WMS GAMES

SERVICE TIP

SUBJECT: JOKERZ AUDIO HUM

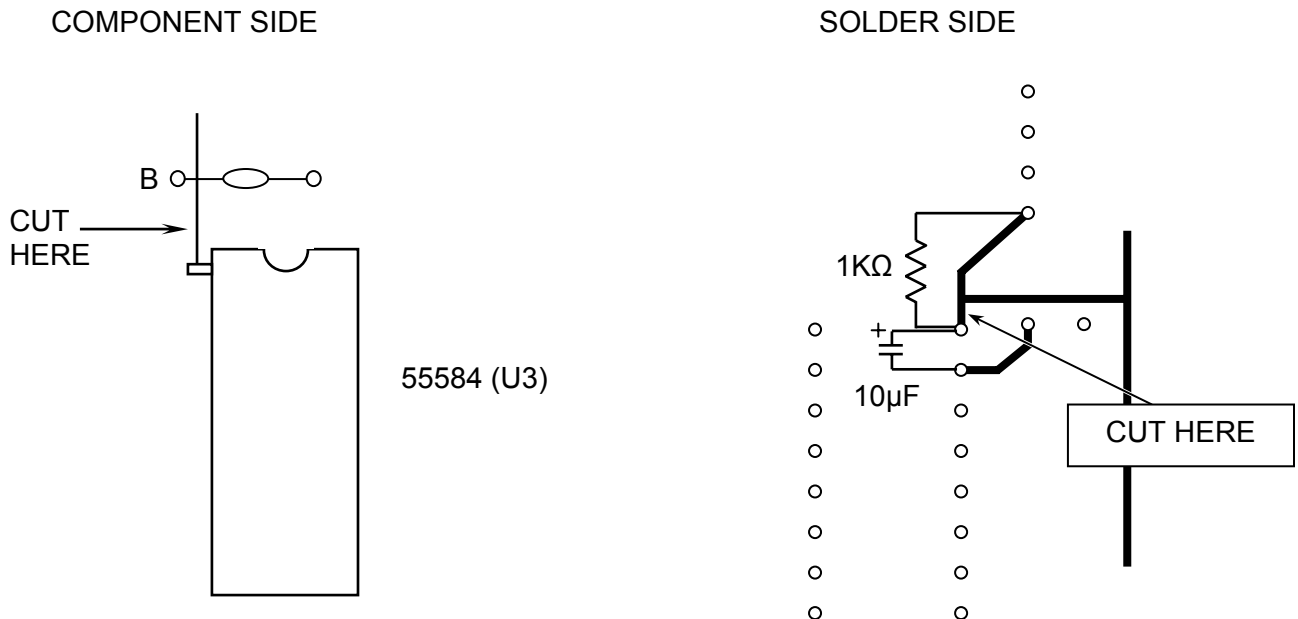
1. PIN 1 OF U3 MUST BE ISOLATED FROM THE +5VDC SUPPLY.

2. BOTH CUTS MUST BE MADE.
3. THEN ADD A 10 μ F CAPACITOR FROM PIN 1 TO PIN 2 ON I.C. U3, WITH THE POSITIVE SIDE SOLDERED TO PIN 1.
4. ADD A 1 K OHM RESISTOR FROM U3 PIN 1 TO U9 PIN 20.
5. MAKE SURE YOU HAVE NO LESS THAN CPU EPROM REV. 6 AND SOUND EPROM REV. 2

THESE MODIFICATIONS WILL GREATLY REDUCE NOISE IN THE AUDIO SYSTEM.
